CoreLink™  
DMA Controller (DMA-330)  
**Errata Notice**

This document contains all errata known at the date of issue in releases up to and including revision r0p0 of PL330 AXI DMA Controller and revision r1p1 of DMA-330 CoreLink DMA Controller.

## **720043: DII 0193A DMAC (PL330) r0p0 IM - Clock enable functionality in pl330\_pl080\_interface is not documented**

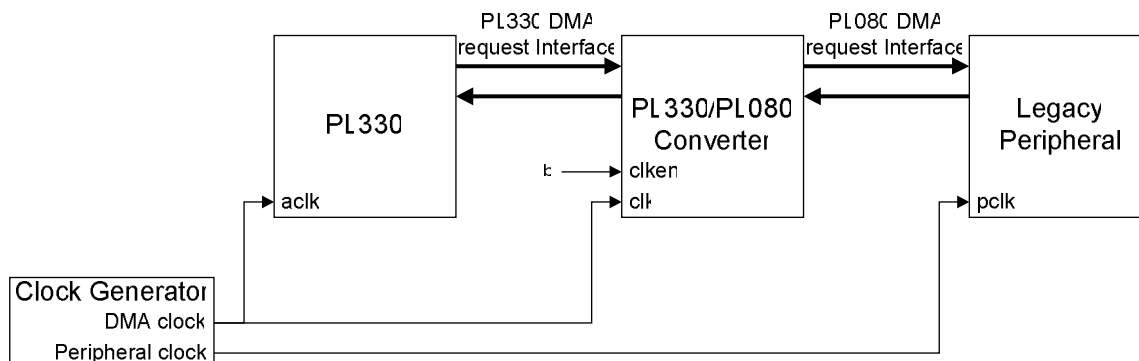
Appendix A of the PL330 Integration Manual describes the DMA Request Interface Converter, which allows you to connect a legacy peripheral that implements a PL080-style DMA request interface to PL330. Figure A-1 "Converter connections" on p.A-2 illustrates the integration of the converter block into a system but does not include the clken input port of the converter.
